Product / Process Change Notification (PCN)

PCN #: PCN_UtLAN_10G_20200504_1

Affected Series: WE-LAN; 74905XXXX

DETAIL OF CHANGE:

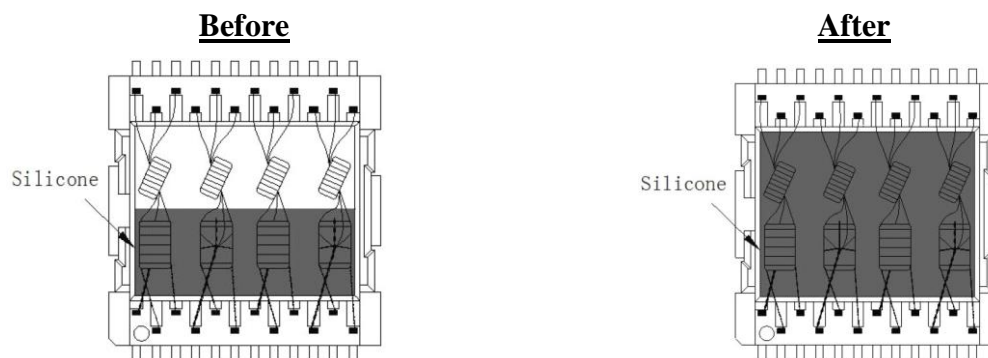
In order to enhance the product reliability, Würth Elektronik will fix both transformer and common mode choke core to the housing. The affected part numbers are: **749050017**, **749050018**, **749053012** and **749053013**.

All products with date code 2020-05-04 or later, will be affected by this change.

There will be no change in form, fit, function or quality of the product.
